REVISION NO. 6 **JUNE 24, 2016**

THE MEDICAL CENTER OF AURORA RENOVATIONS
Aurora, Colorado

ESa PROJECT NO. 14077.00

These revisions form a part of the Contract Documents and modify the original CONSTRUCTION DOCUMENTS, dated December 30, 2014, as outlined here in addition to being shown on the drawings as Delta No. 6, dated June 24, 2016.

FIRST FLOOR SOUNDWALL PLAN - PART A

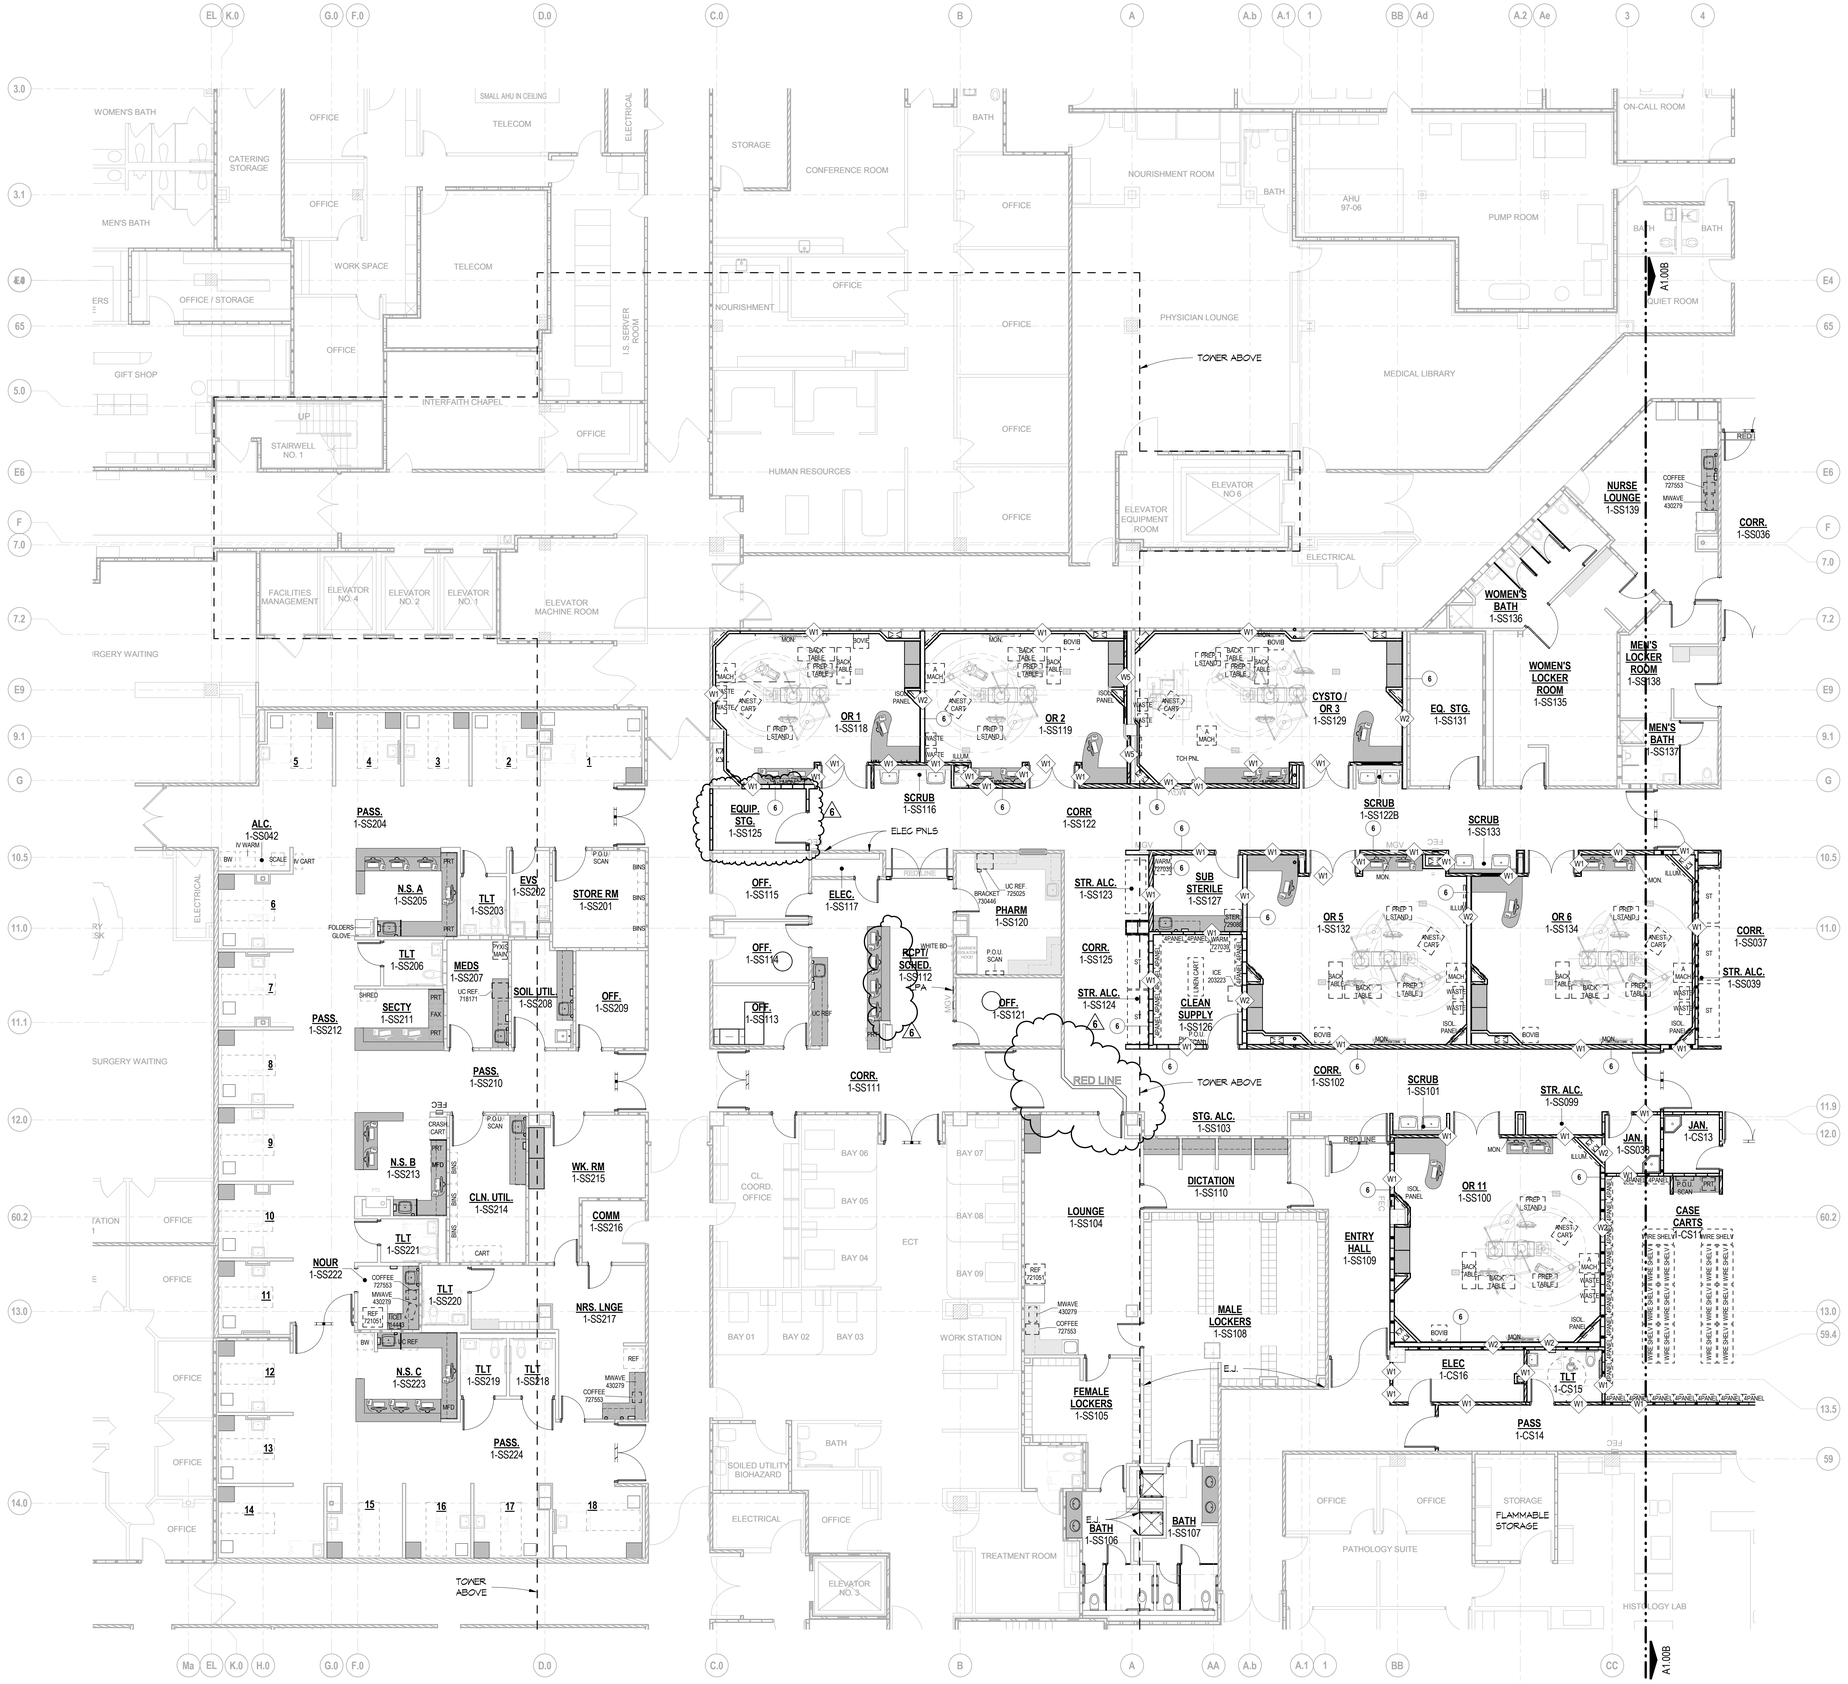
A1.00A– FIRST FLOOR SOUNDWALL – PART A
1. Eq. Storage room 1-SS125 added.
2. Redline adjusted.
3. Doors at lounge and office adjusted.

FIRST FLOOR SOUNDWALL PLAN - PART B

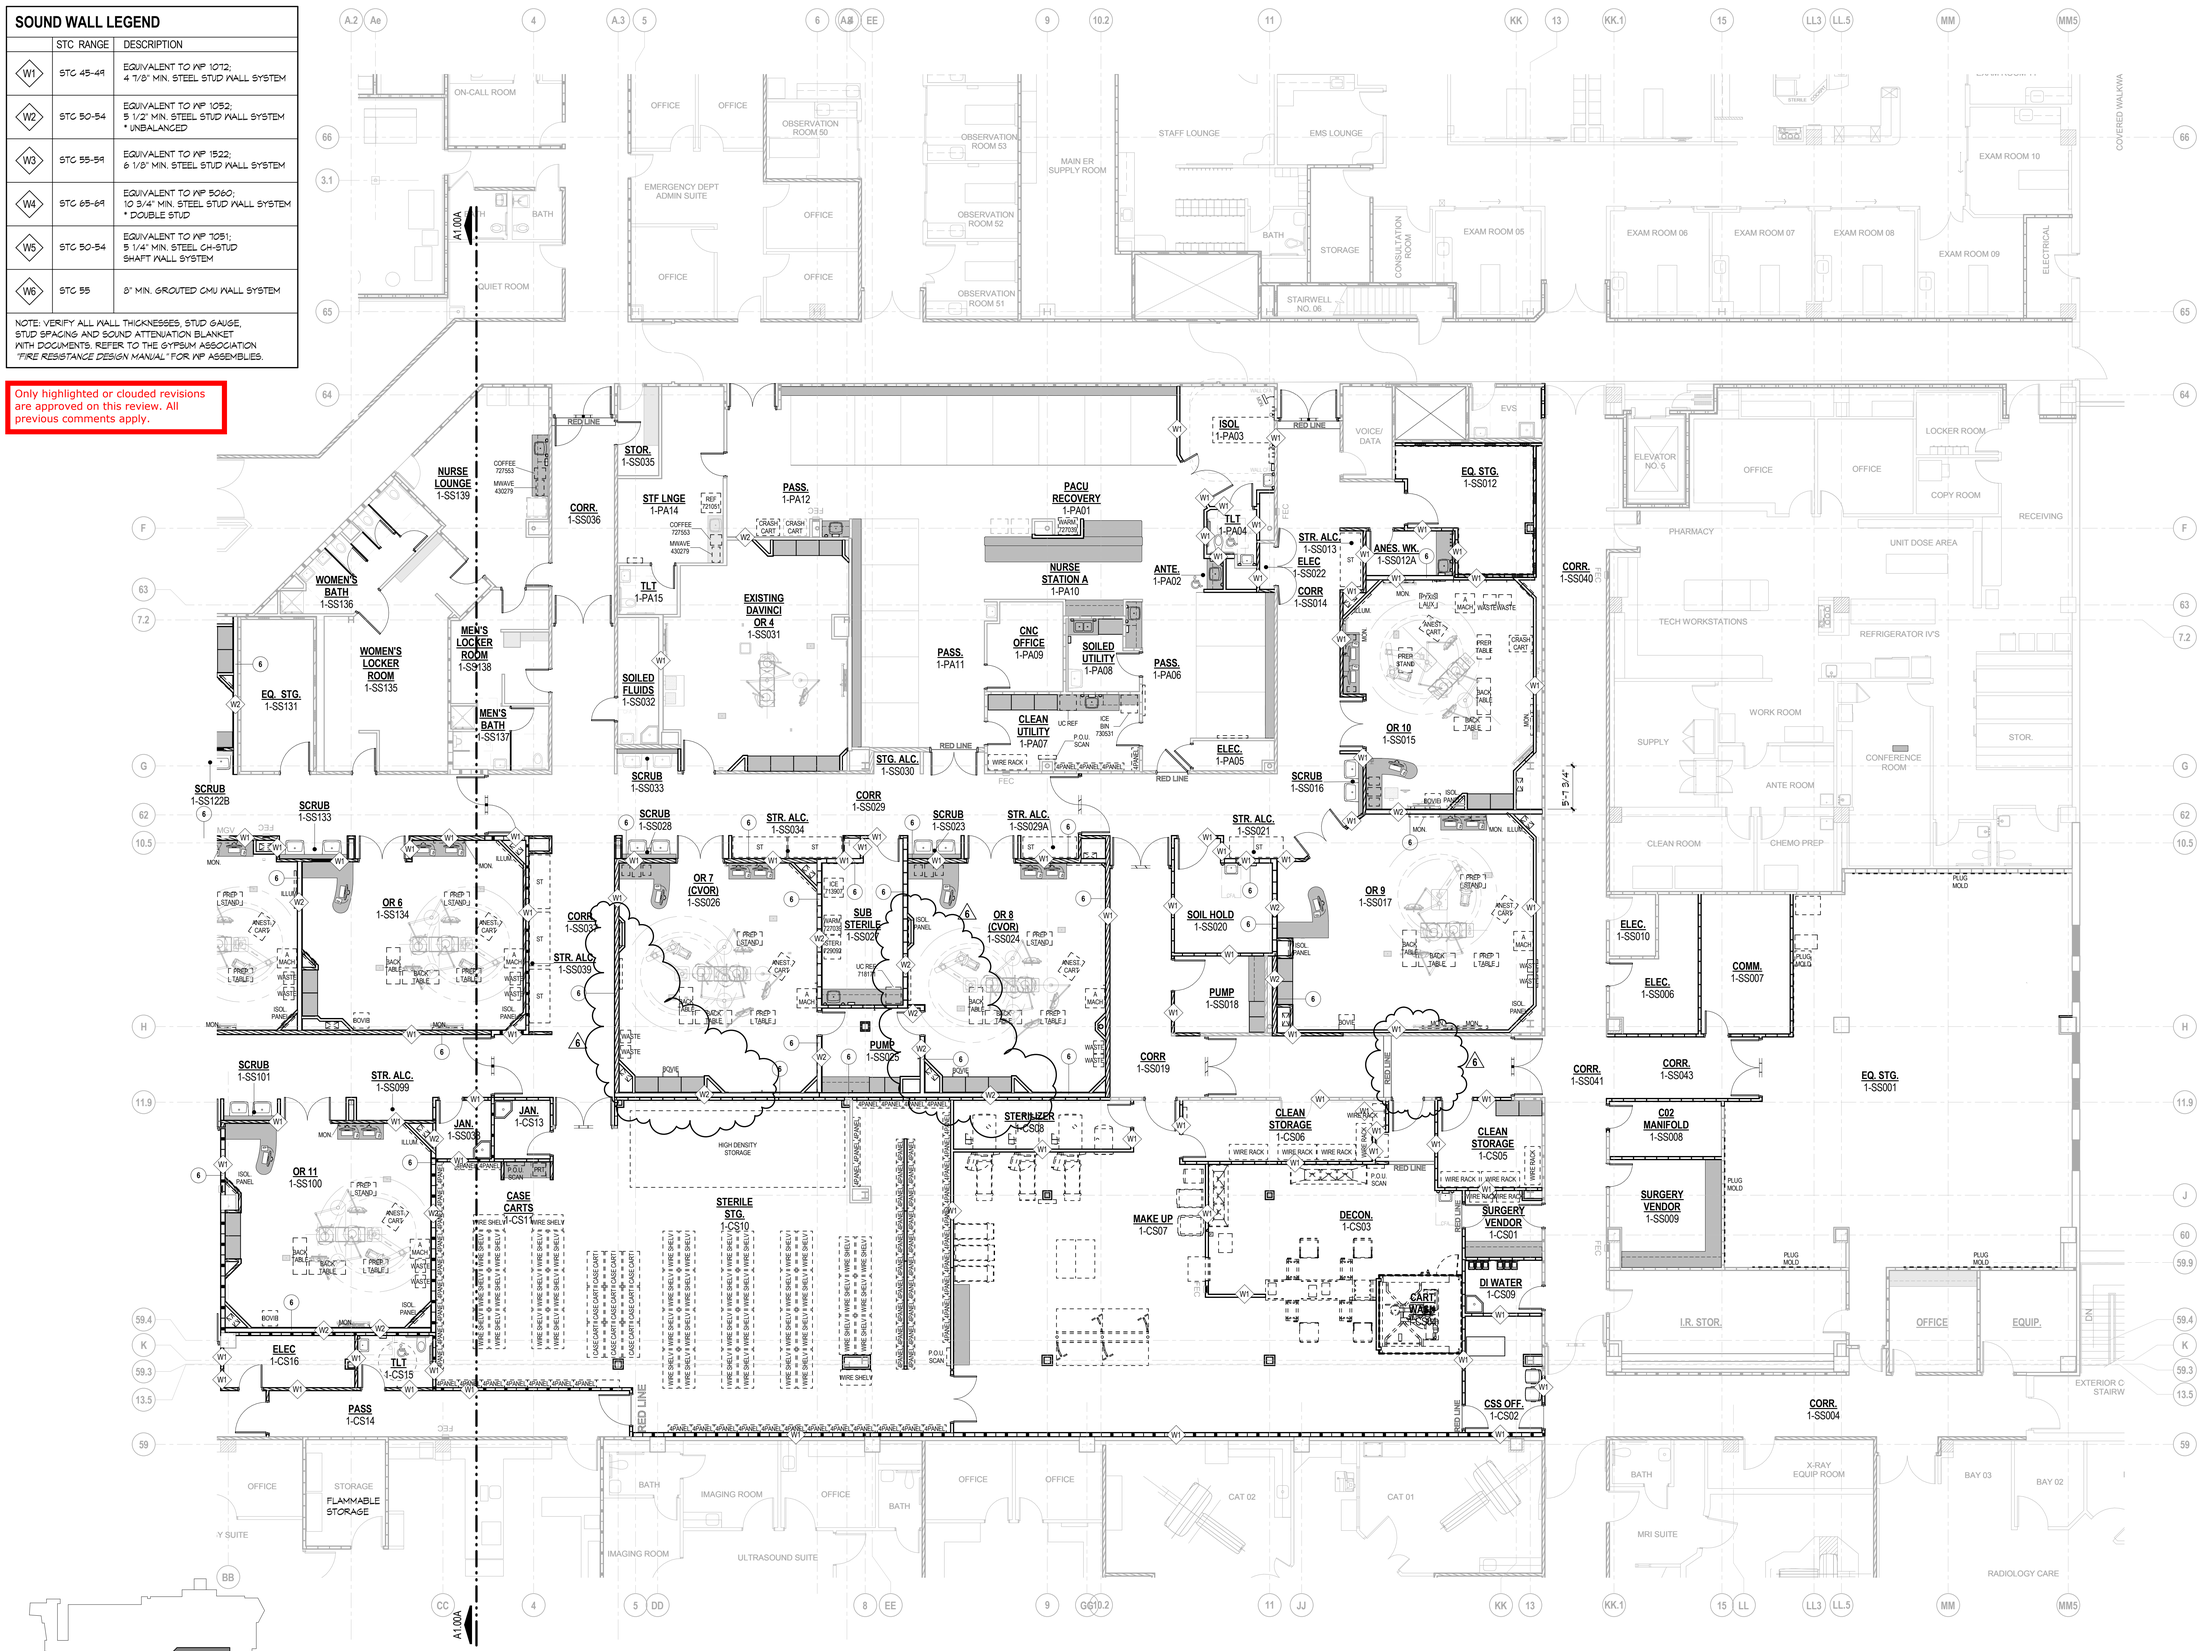
A1.00B– FIRST FLOOR SOUNDWALL – PART B
1. Adjusted layout at OR 7 and 8 due to field conflicts.
2. Adjusted Redline added.

A1.03.1

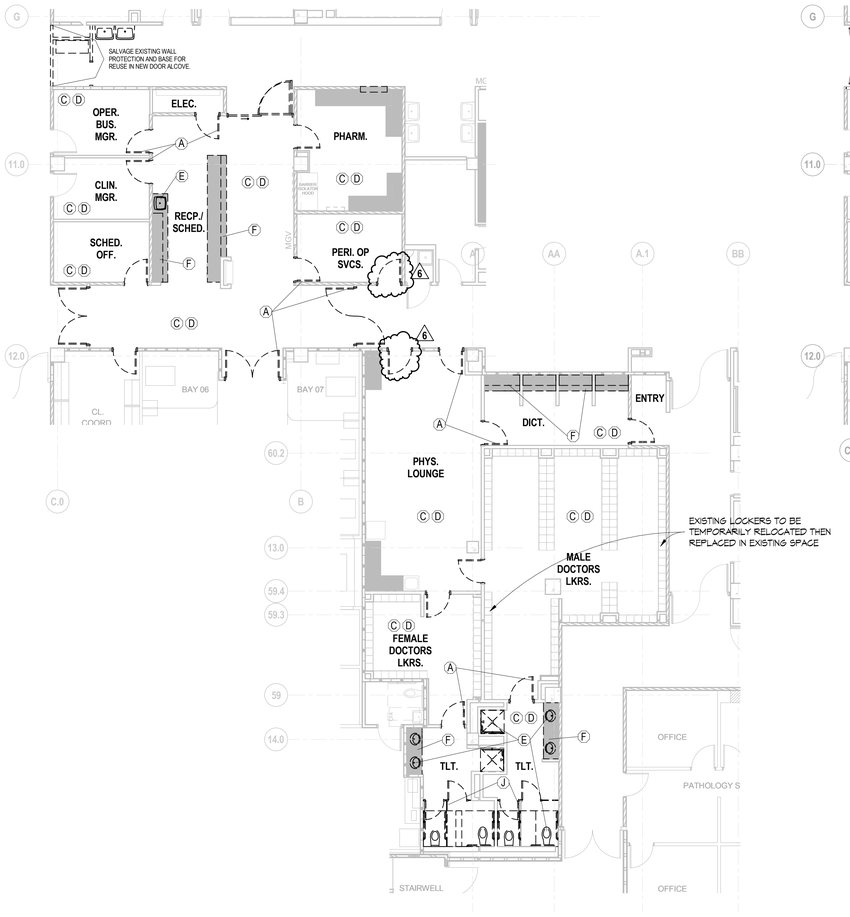
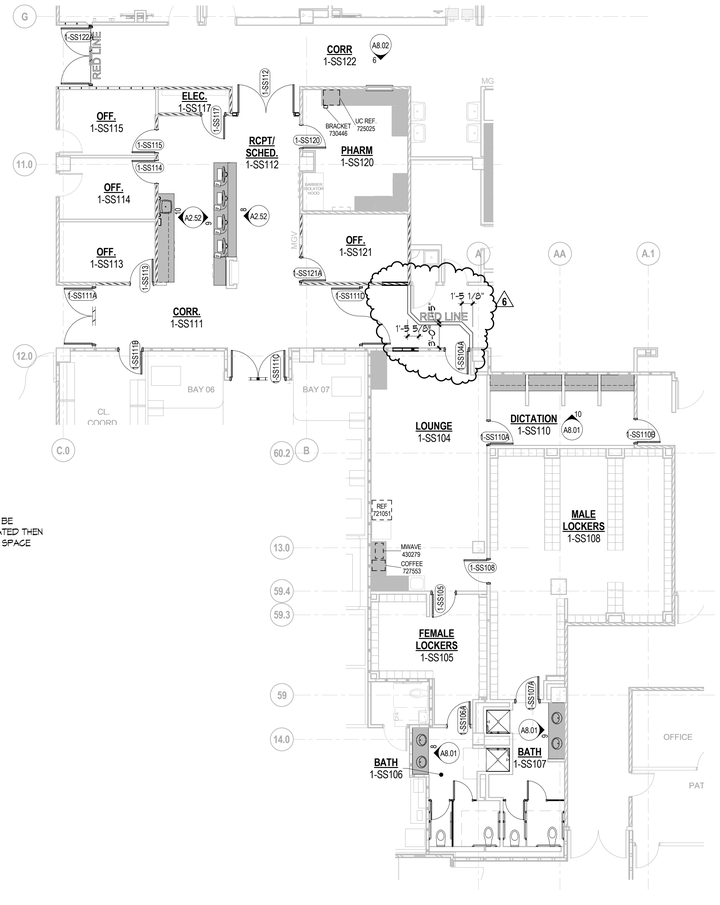
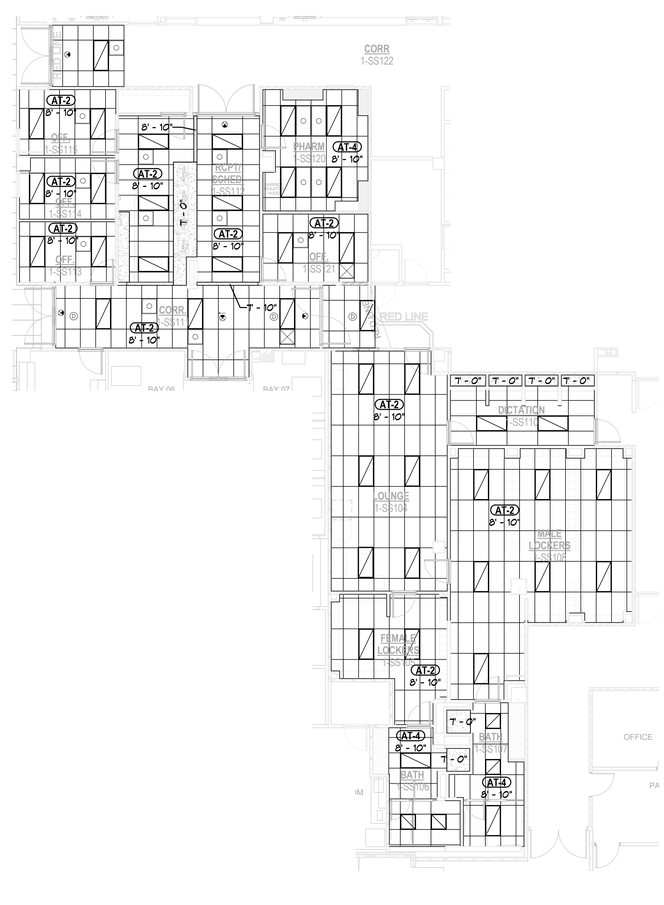
A1.03.1– PHASE III – LOCKERS/ O.R. CONTROL
1. Doors removed per Owner request.
2. Redline adjusted per Owner request.

A1.03

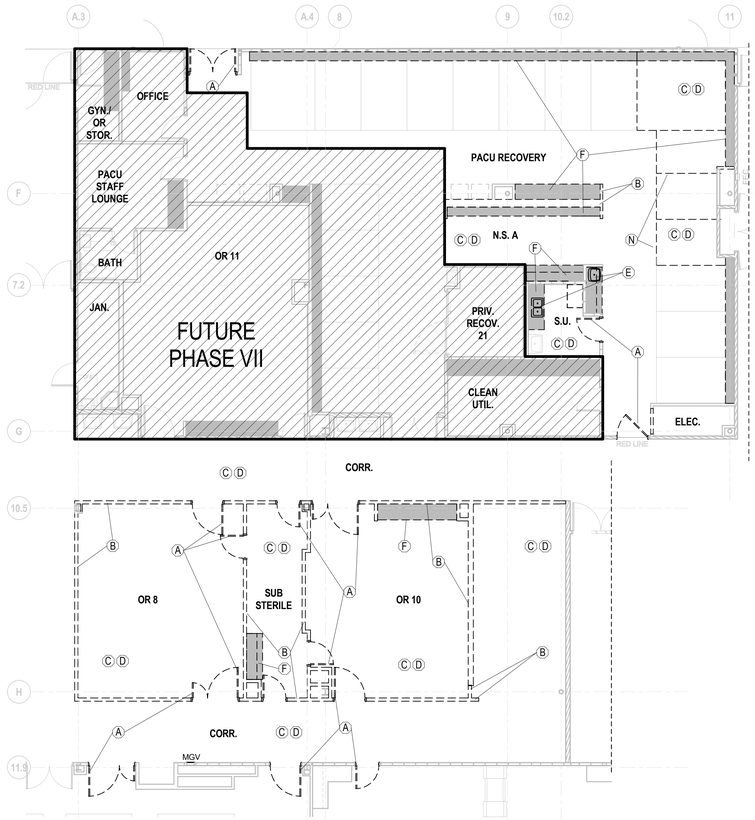
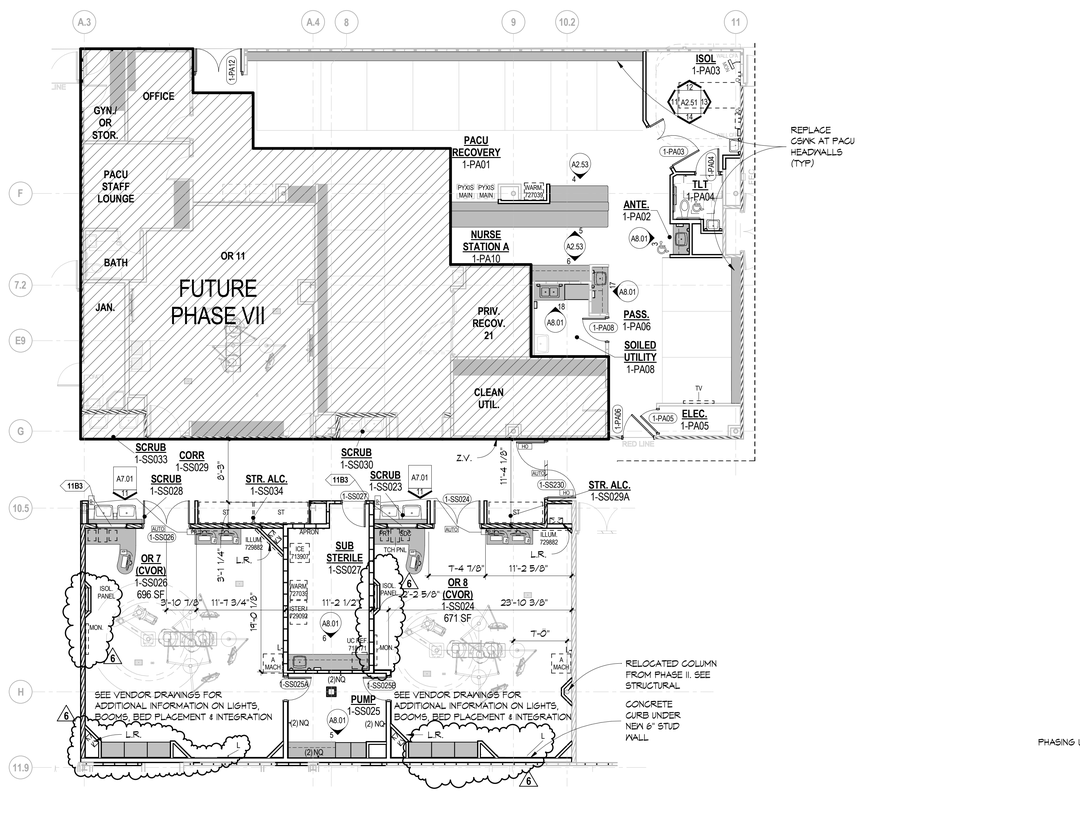
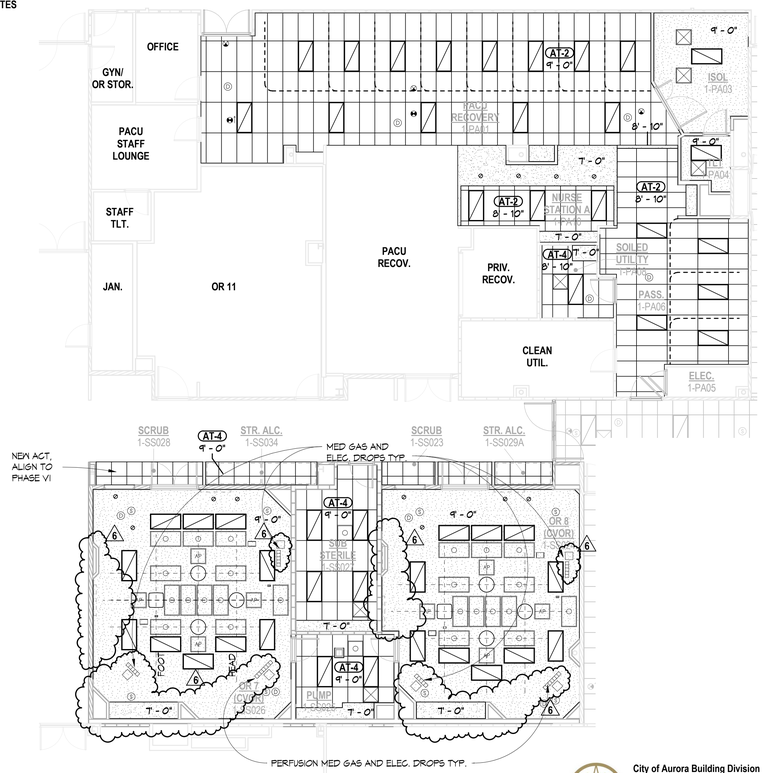
A1.03– PHASE III PACU & O.R.'S
1. Casework and Isolation Panel locations adjusted per field conditions in O.R. 7 & 8.
2. Ceilings adjusted in OR 7 & 8 per Owner request.
